# Access Compliance Report

## Public Rights-of-Way

### (Curb Ramps)

Intersection ID: 8047	Main Street: N_HOSKINS_RD	Cross Street: ROZZELLES_FERRY_RD	Location: E
ADA ID: 747426FEA428	Ramp Type: Perp	Initial Pass/Fail: Fail	Overall Compliance: No
Codes/Mitigation Info/Possible Solution		Field Measurements/Component Compliance	
Severity Score: 21.25

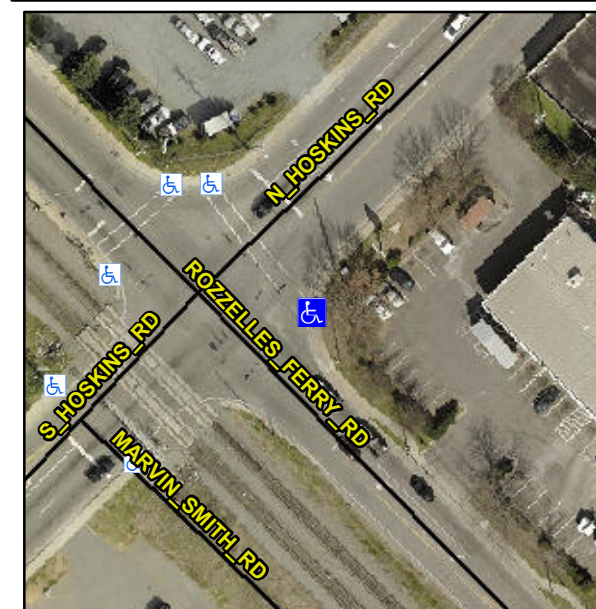
**Not Found, R304.5.1, R304.2.2**

Compliance	Description	Data	Compliance	Description	Data
N/A	Ramp Length (in)	62.0	No	Ramp Slope (%)	9.7
No	Ramp Width (in)	45.0	Yes	Ramp XSlope (%)	0.7
N/A	Flare Type LT	N/A	N/A	Flare Type RT	N/A
N/A	Flare Slope LT (%)	N/A	N/A	Flare Slope RT (%)	N/A
N/A	Flare Traversable LT?	N/A	N/A	Flare Traversable RT?	N/A
N/A	Landing Length (in)	N/A	N/A	DWS Provided?	N/A
N/A	Landing Width (in)	N/A	N/A	DWS Contrast?	N/A
N/A	Landing Slope (%)	N/A	N/A	DWS Length (in)	N/A
N/A	Landing X Slope (%)	N/A	N/A	DWS Full Width?	N/A
N/A	Landing Curb? (Y/N)	N/A	N/A	DWS Offset (in)	N/A
N/A	Shared Landing?	N/A			
N/A	Gutter Ponding?	N/A	N/A	Gutter Slope (%)	N/A
N/A	Gutter Lip Ht (in)	N/A	N/A	Gutter X Slope (%)	N/A
N/A	Painted X Walk1?	No	N/A	Painted X Walk2?	N/A
	X Walk 1 Direction	To N		X Walk 2 Direction	N/A
N/A	X Walk 1 Width (in)	N/A	N/A	X Walk 2 Width (in)	N/A
	X Walk 1 Slope (%)	2.3		X Walk 2 Slope (%)	N/A
	X Walk 1 X Slope (%)	1.5		X Walk 2 X Slope (%)	N/A

**Remove & Replace Entire Ramp.**
